PUR-1378
ADDENDUM NO. 2
INVITATION TO BID

THE MARYLAND THEATRE EXPANSION
IN HAGERSOWN, MARYLAND

DATE: Monday, March 26, 2018

BASEMENT FLOOR PLAN - MECHANICAL
1/8" = 1'-0"

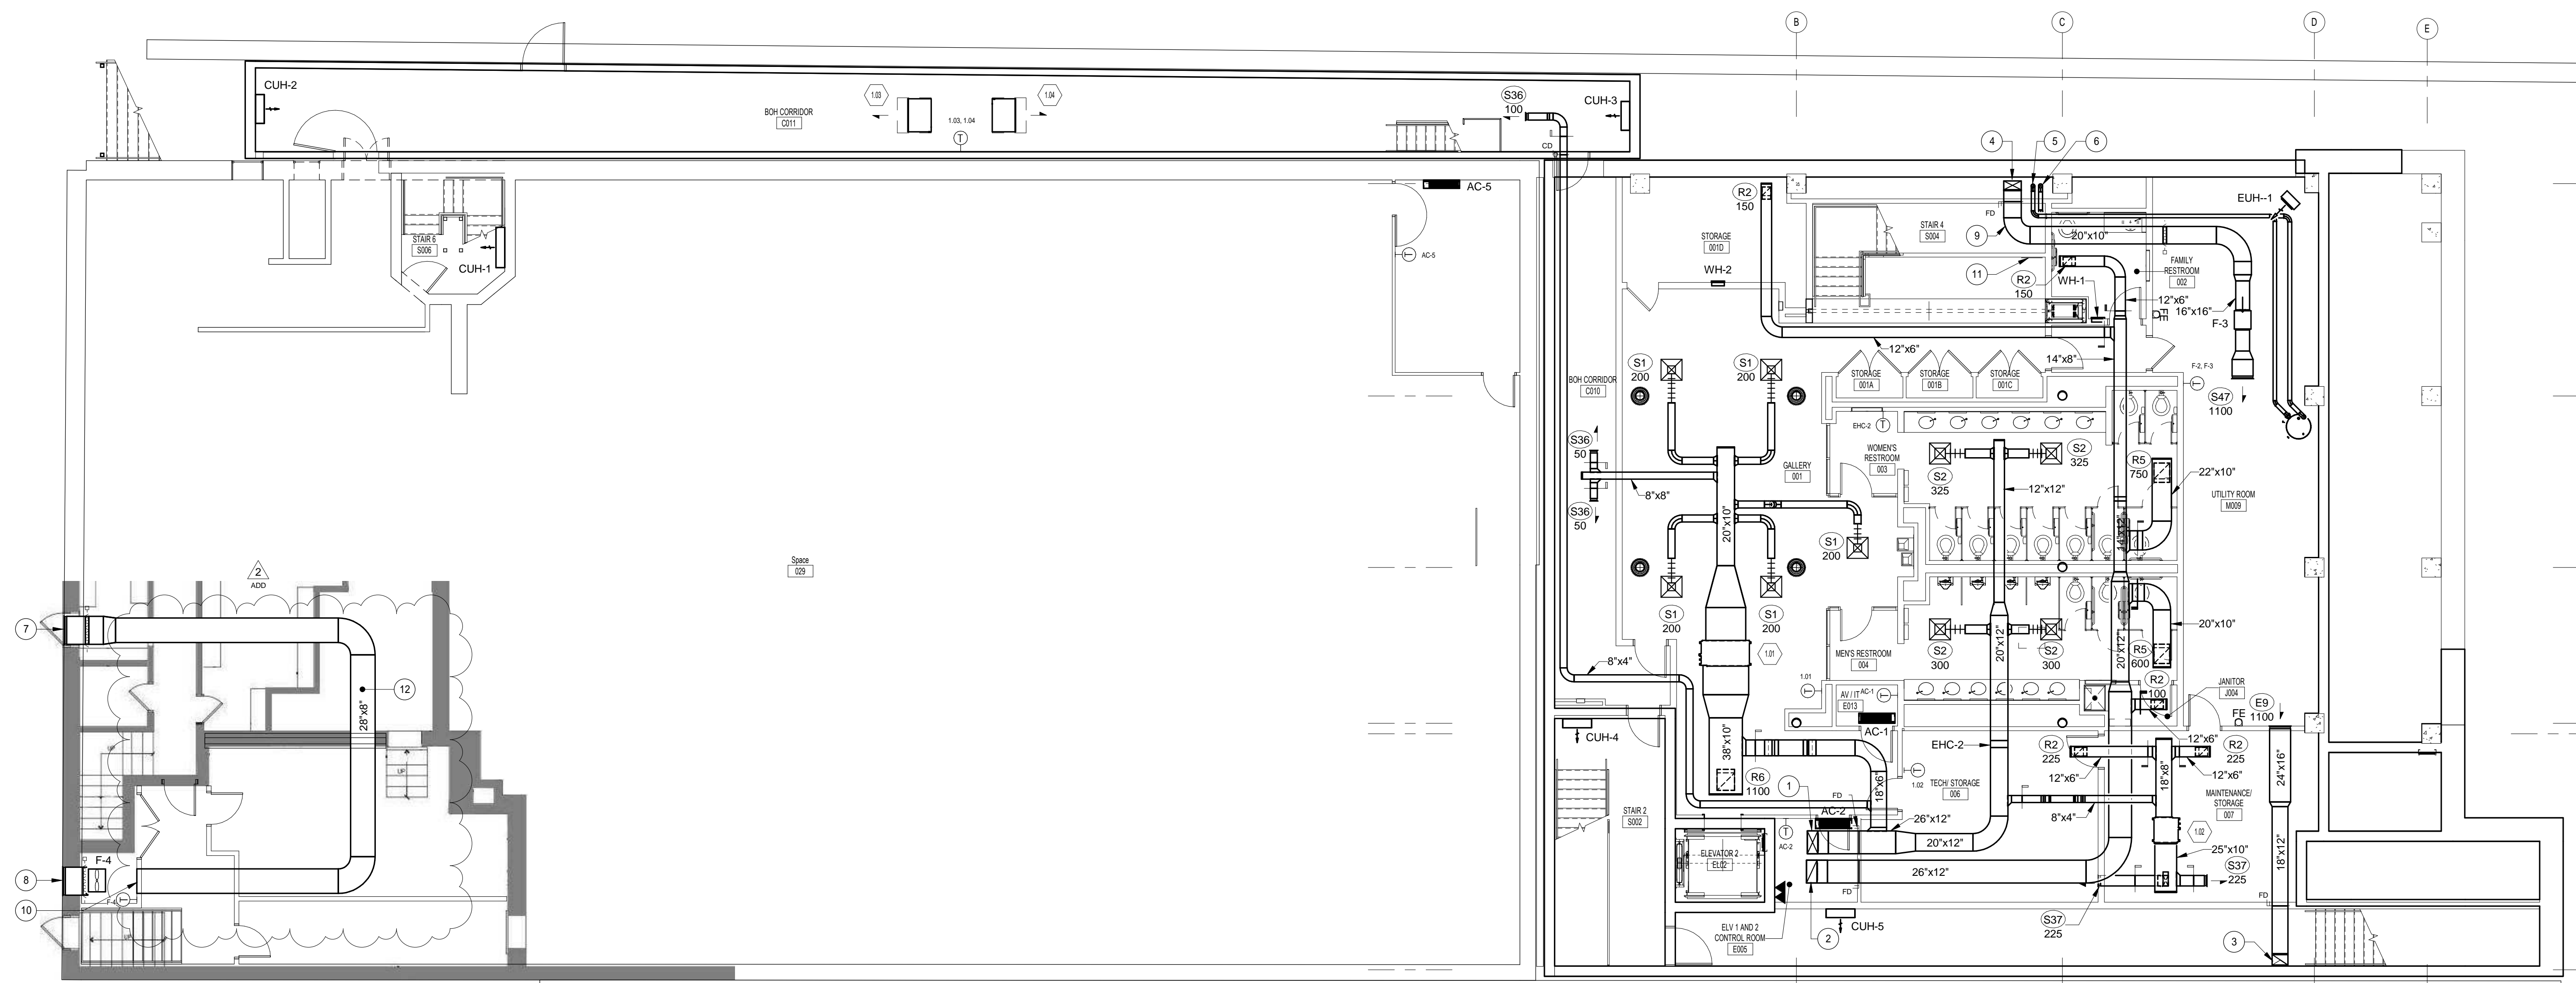
- REVISE** Revise SF Mullion Detail 6A
- ITEM NO. 105** SHEET M-2.1 – BASEMENT FLOOR PLAN – MECHANICAL *(SHEET ATTACHED)*
- REVISE** O/A intake ductwork serving electrical room. Ductwork to be re-routed through laundry room. See attached revised sheet M-2.1

- ADD** Thermostat to electrical room to be interlocked with F-4. See attached revised sheet M-2.1
- ITEM NO. 106** SHEET E-5.1 – SCHEMATIC POWER RISER DIAGRAMS *(SHEET ATTACHED)*
